Technical Service Bulletin

No.LTB00030v2
15 February 2007

Subject/Concern: Steering Wheel Vibration/Steering Shimmy
--

Range Rover Sport (LS)		VIN-range: 5A900018 Onwards
Range Rover (LM)		VIN-range: 2A100003-5A198056

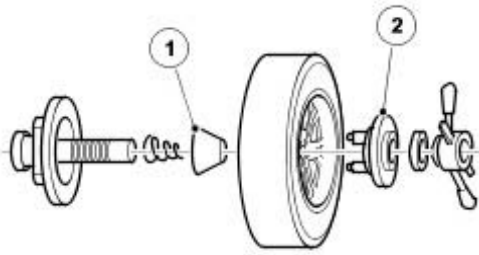
4 . Raise vehicle on the lift immediately on returning to the workshop, to avoid inducing further tire flat spots.

5 . Remove all four road wheel and tire assemblies for balancing (see Global Technical Reference GTR Workshop Manual, section: 204-04).
